**SAN LEANDRO SENIOR CENTER - PHASE 2  
PROJECT NO. 06-210-18-116**

**ADDENDUM NO. 3**

July 16, 2008

ADDENDUM 3  
REVISION  
AD3-6/A8.13-01  
DRAWING

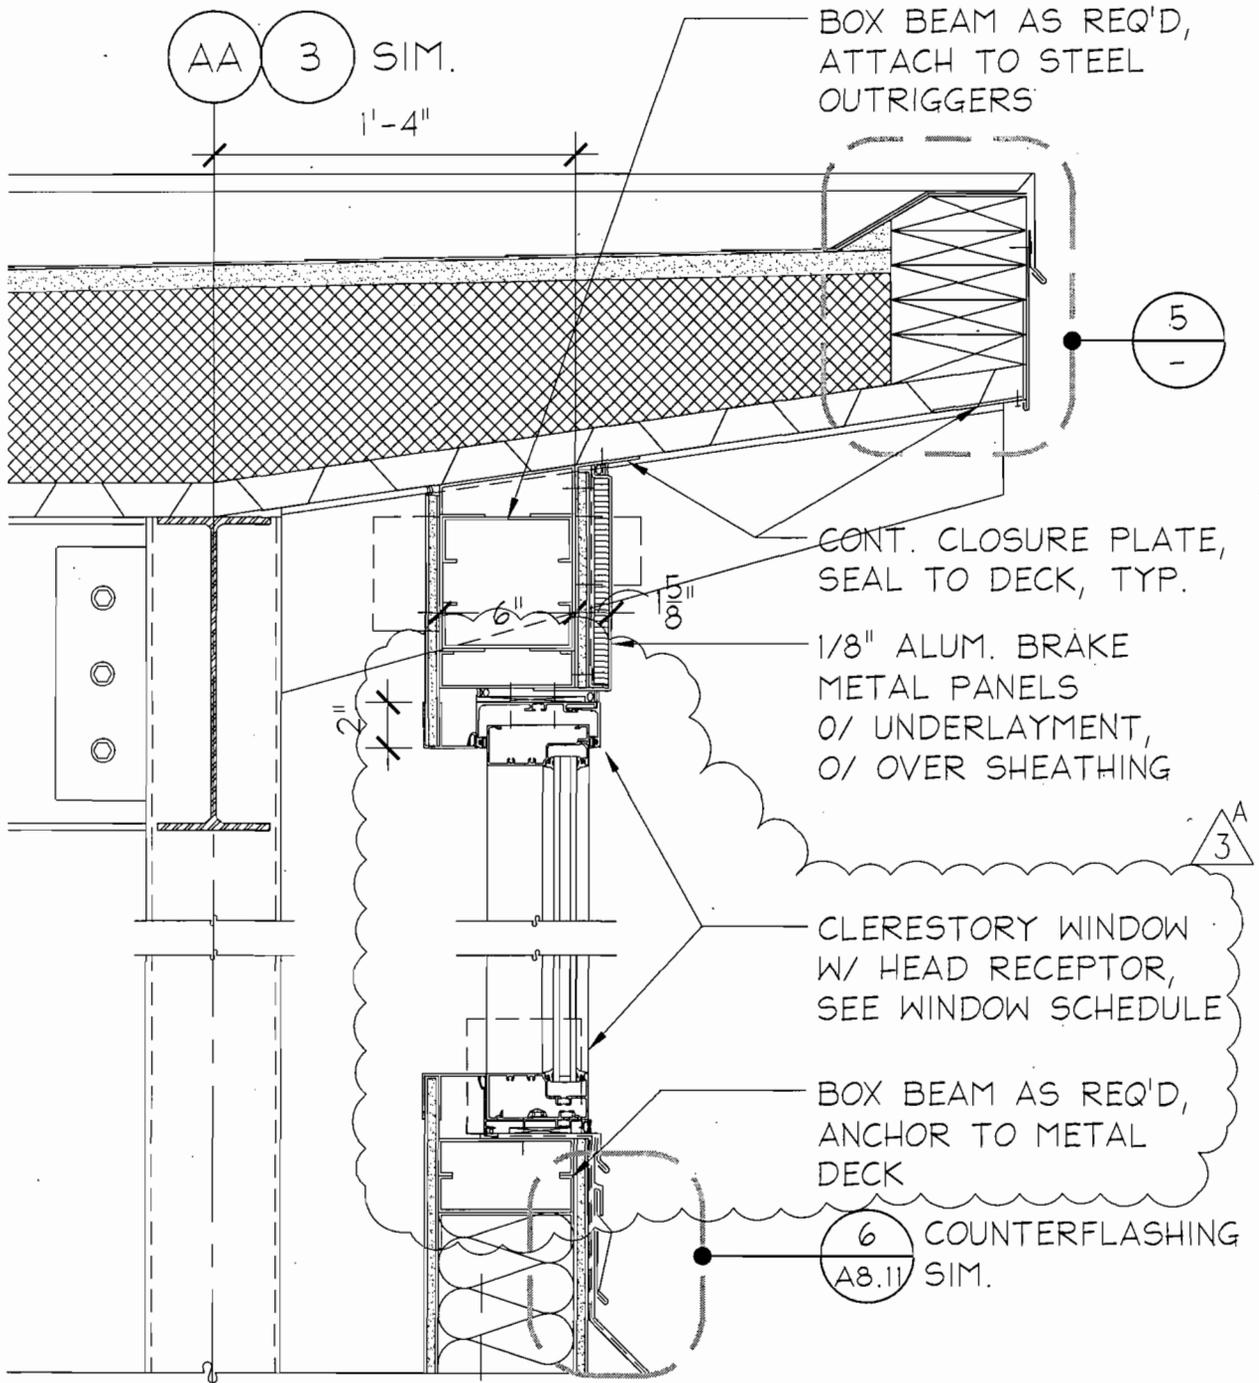
- D-29. Sheet A8.13 Exterior and Roof Details:  
Sketch AD3-6/A8.13-01: REVISE detail 6, Change window frame to have a head receptor and revise detail callouts.

Response: Box beam can be provided to support header and sill of window opening. Windows 27A, 27B, 27C has been revised to use compensating channel. See Drawing Change D-29.

ADDENDUM 3  
REVISION  
AD3-1/M1.1A-01  
DRAWING

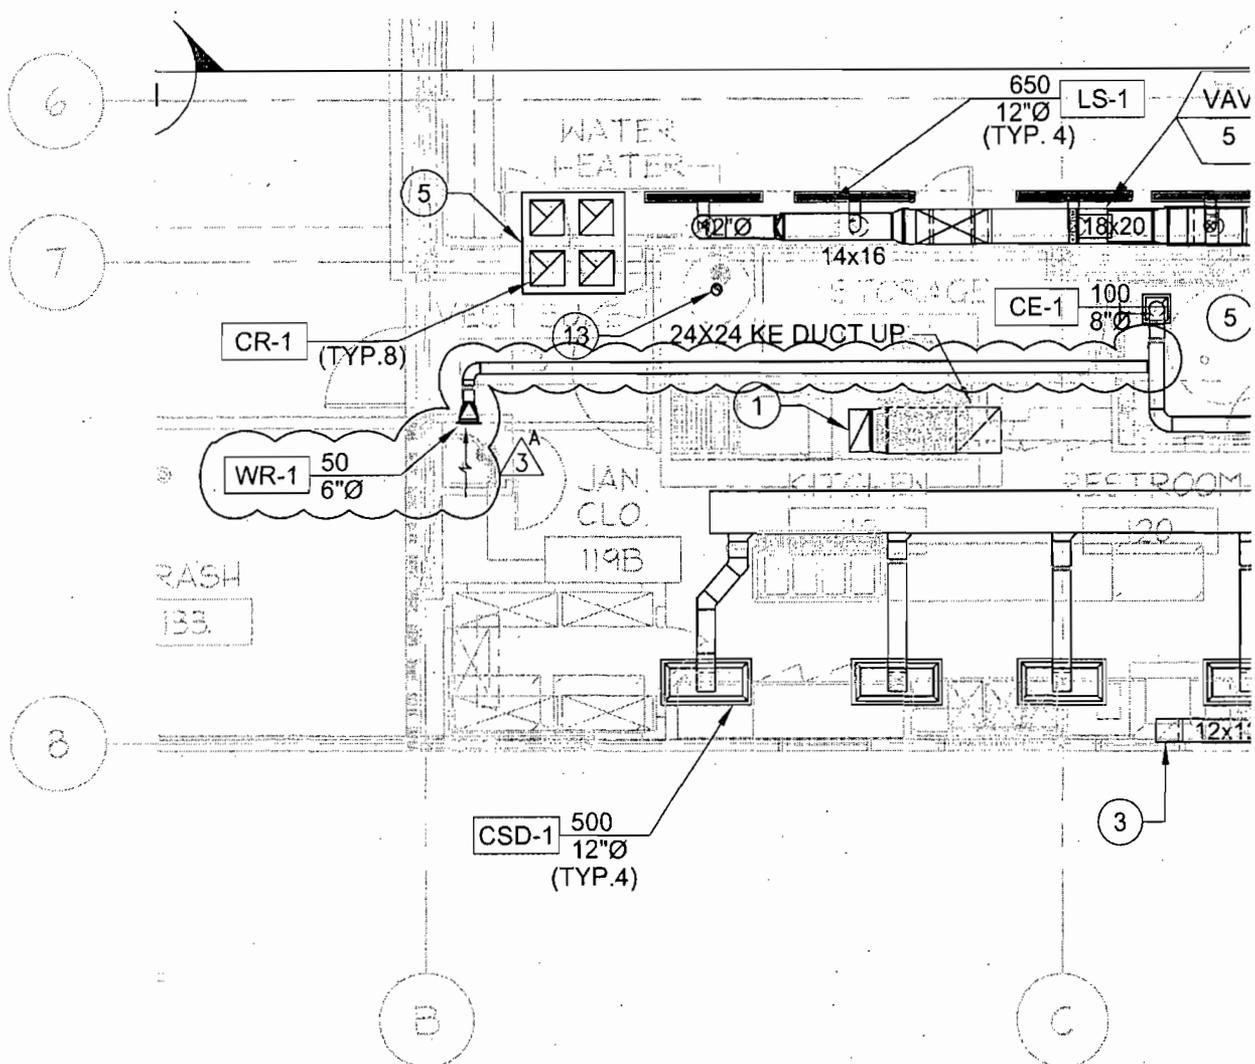
Sketch AD3-1/M1.1A-01, ADD Exhaust grille in room 119B and associated ductwork as indicated.

ADDENDUM 3  
REVISION  
AD3-1/M5.2-3  
DRAWING

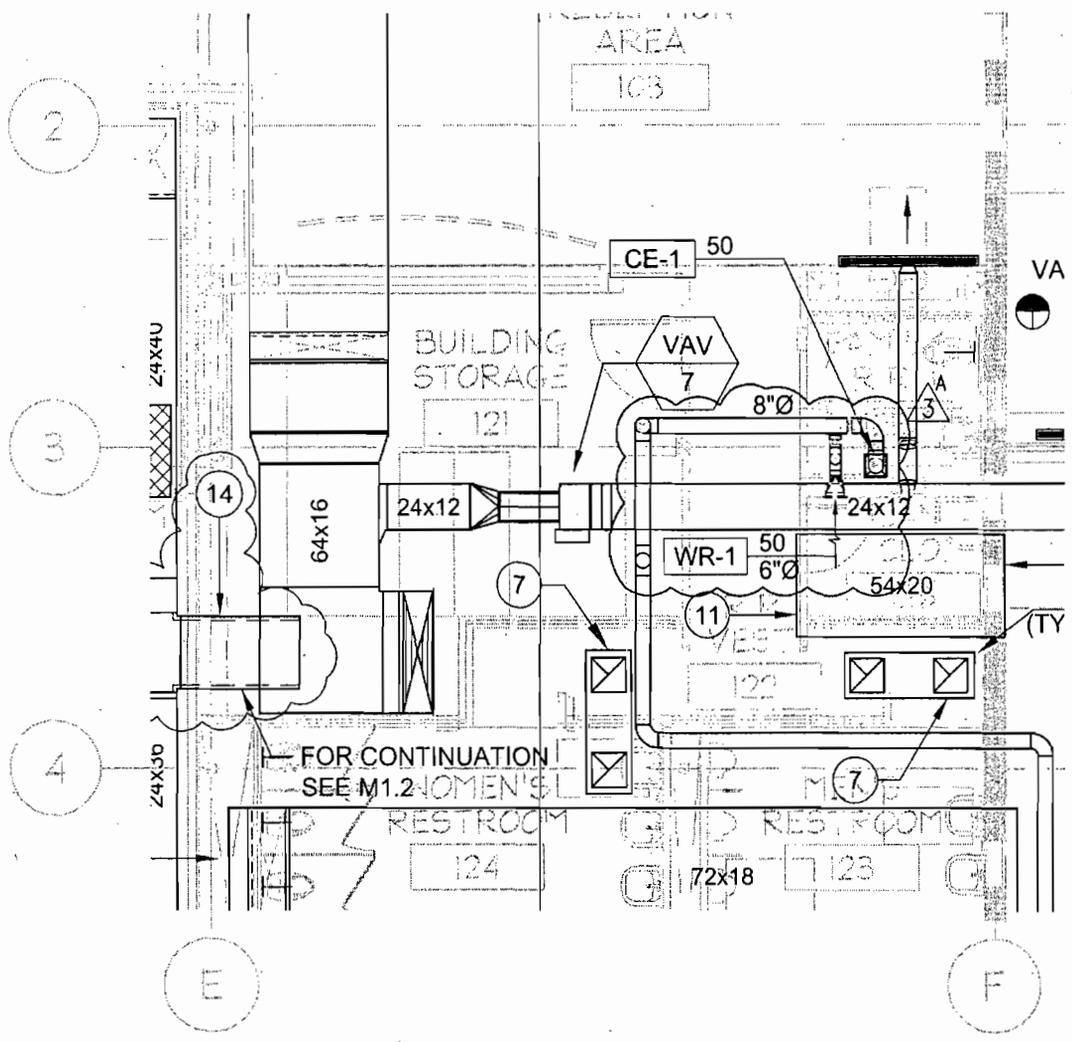
Sketch AD3-1/M5.2-3, REVISE Electrical data for EF-3 and EF-4.

**A9.11**  
SHEET 149 OF 310  
JOB NO. 06-210-18-116  
SCALE  
DWG. 3281 CASE 901

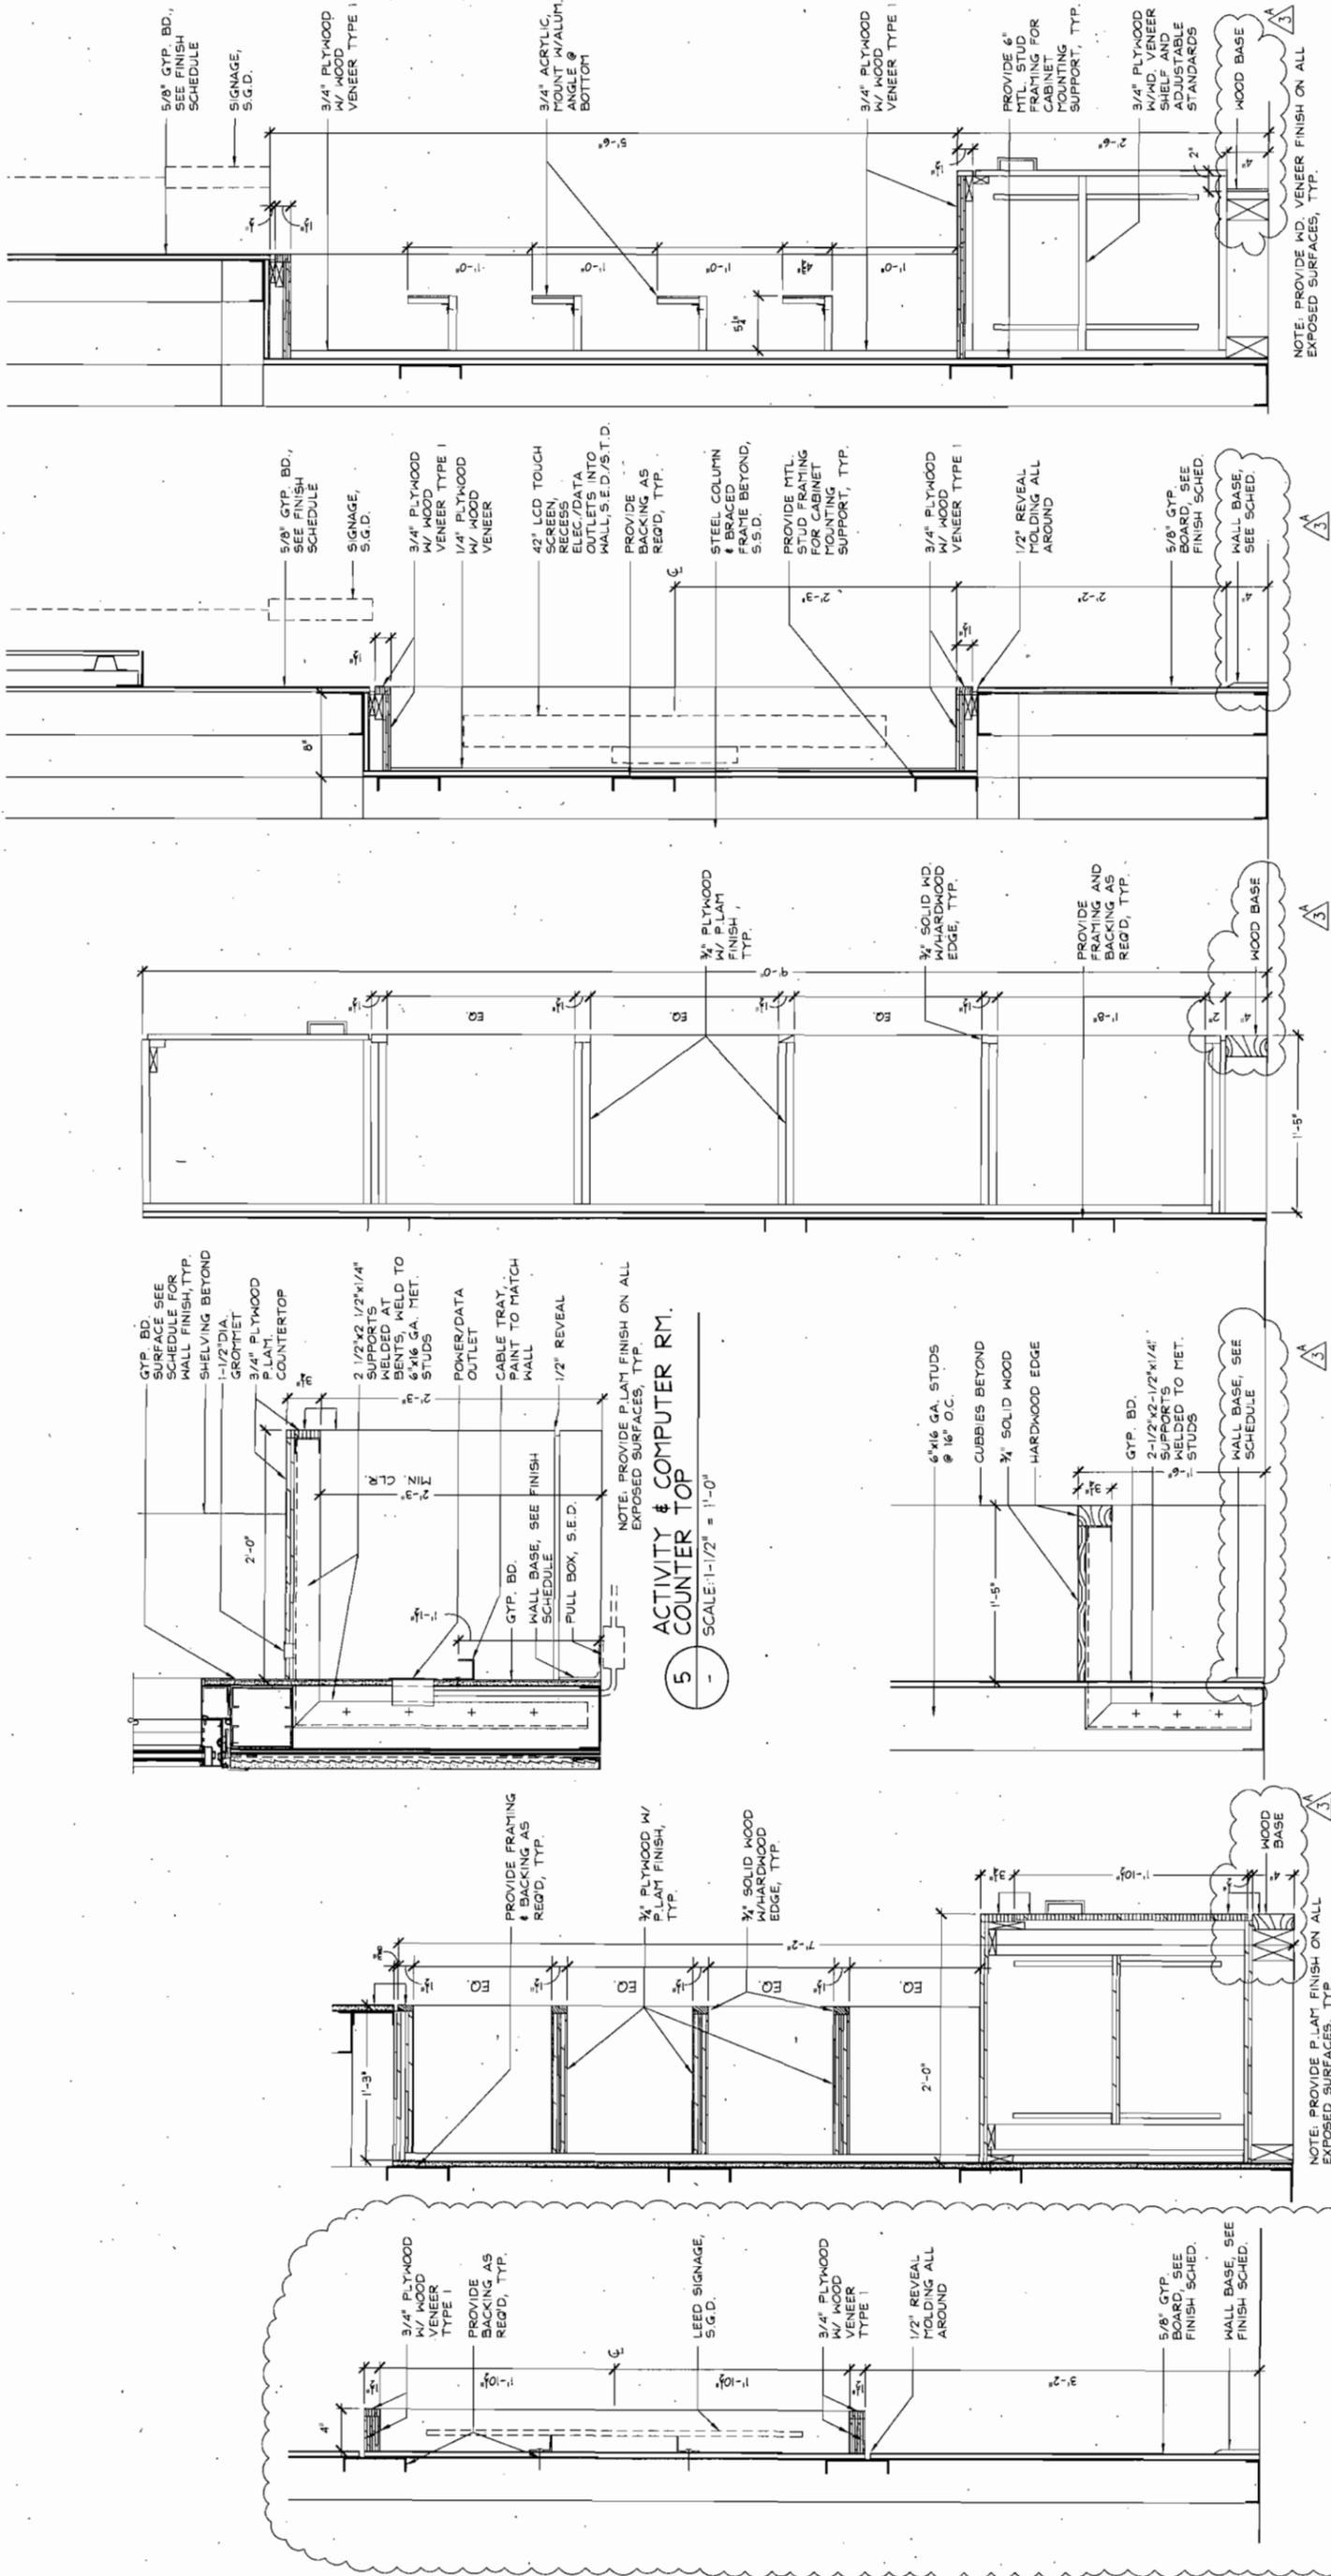
Reissue A9.11: ADD new detail 7, Wall Display Casework for LEED Educational Signage.  
REVISE casework base on details 1, 2, 3, 4 and 6.

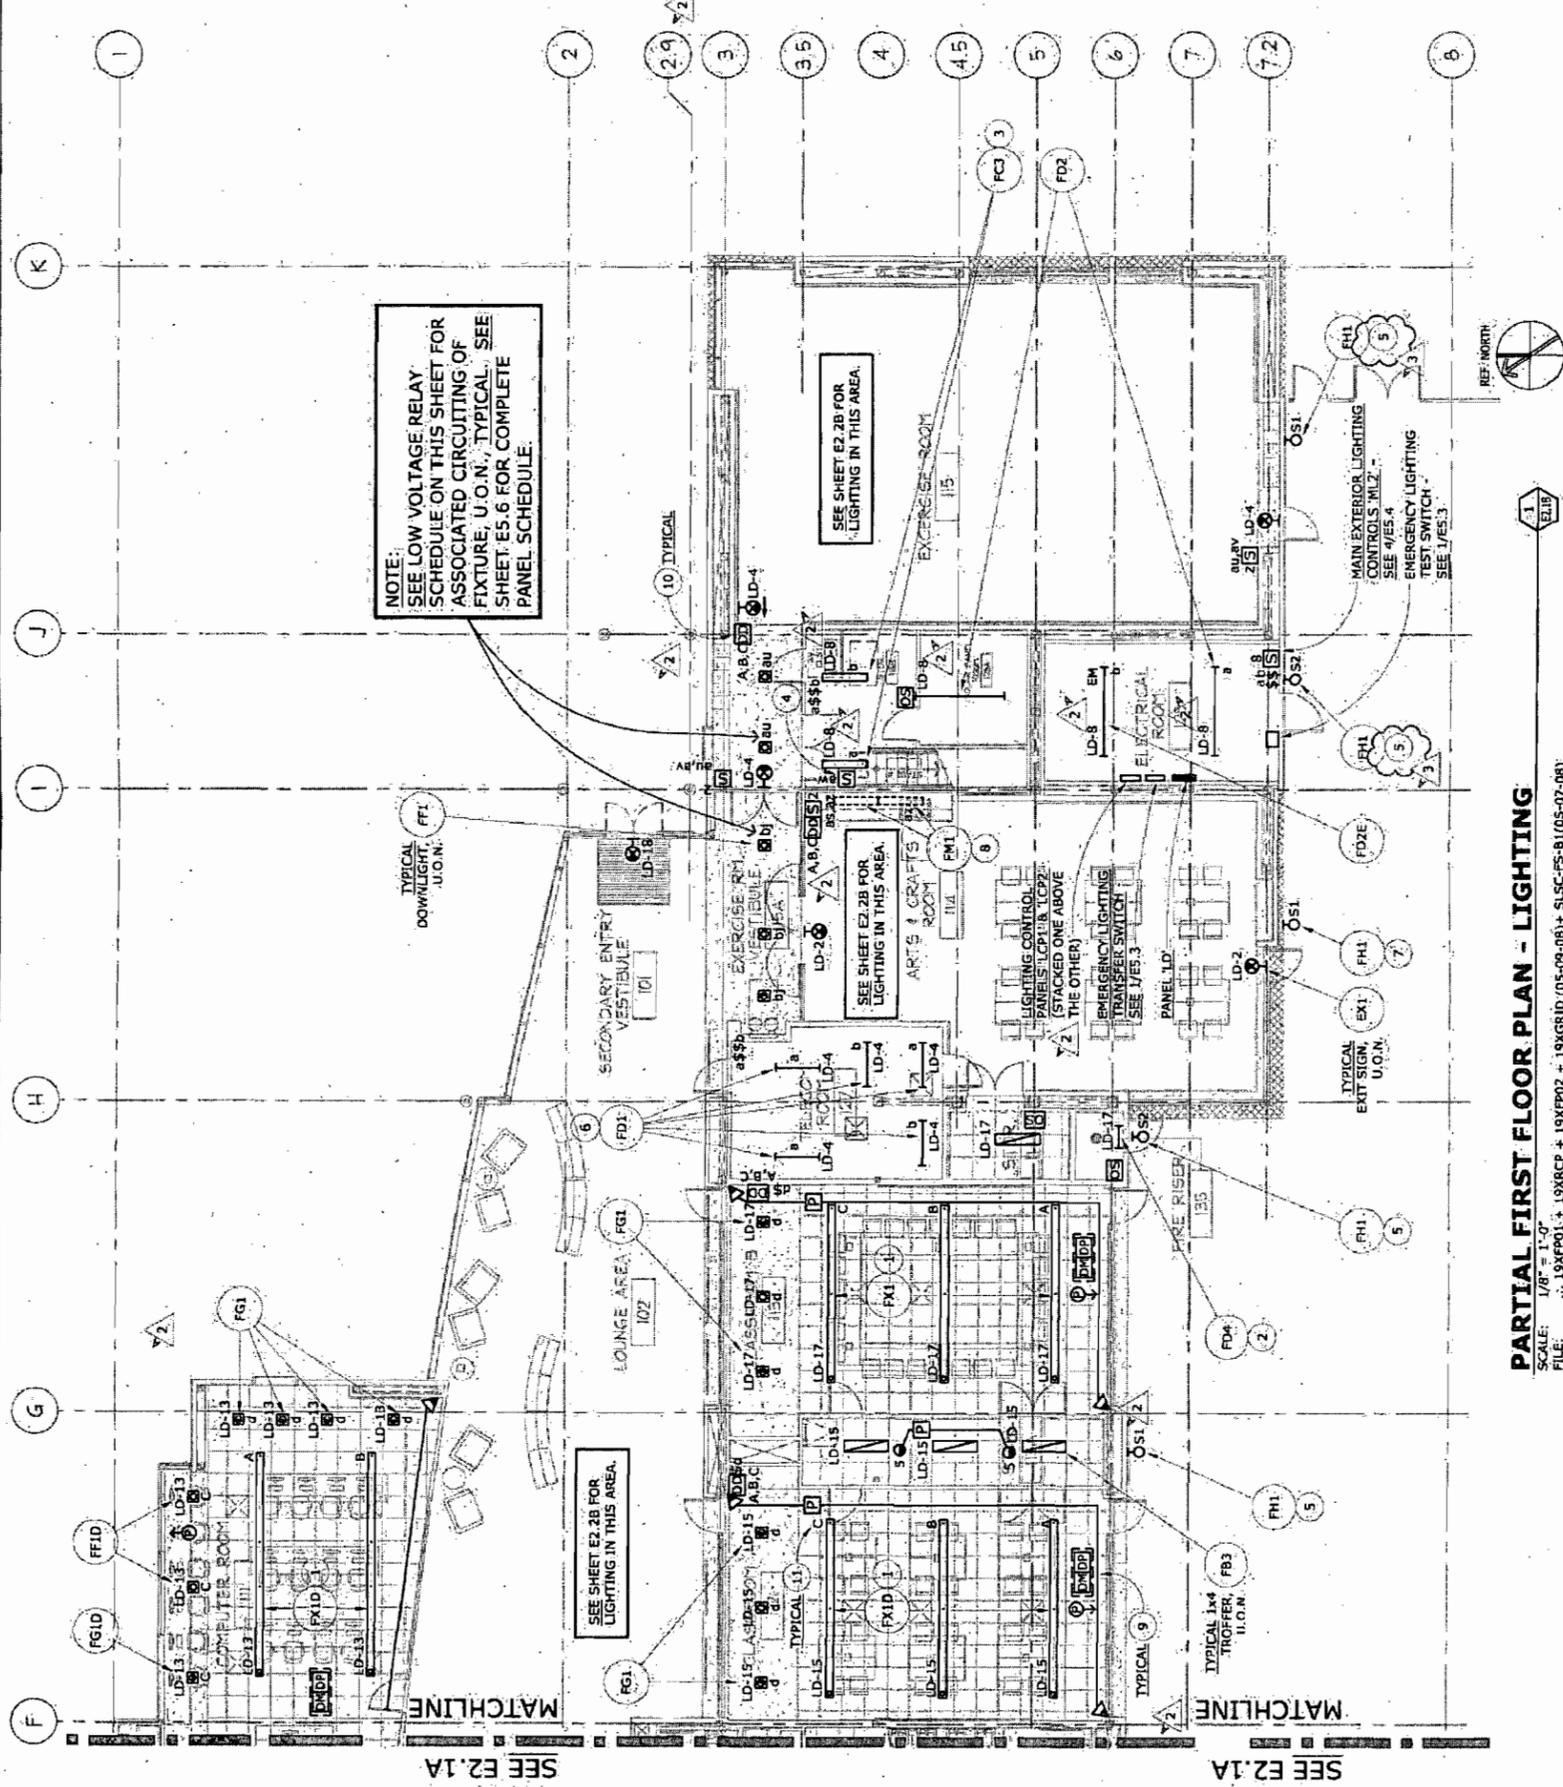
REISSUE E2.1A and E2.1B in their entirety, showing correct lighting layout for 110, 110A, 104A, 104B, 105, 106, 107, 108 and Main Hall Platform. These reissued sheets should replace the sheets included in the BID set that are incorrect due to a printing glitch.

- CHANGE numbered sheet note for (2) FH1 luminaires on the west wall of Trash Enclosure 133 and Activity Room 110.
- ADD (1) FH1 luminaire on the south wall of Kitchen 119 and relocate (1) luminaire.
- CHANGE numbered sheet note for (4) FH1 luminaires on the south wall of Kitchen 119.

- CHANGE numbered sheet note for (2) FH1 luminaires on the south wall of Electrical Room 128 and Exercise Room 115.

- Q-35. Sheet E2.1A: Lighting layout of rooms 110, 110A, 104A, 105, 106, 107, 108 and platform at main hall "B" seems incomplete. Please verify? What is lighting fixture type for room 104B?

Response: Sheet E2.1A and E2.1B has been reissued, see Drawing Change D-36 of this Addendum. There seems to be a printing glitch on these sheets as issued in Bid Set.
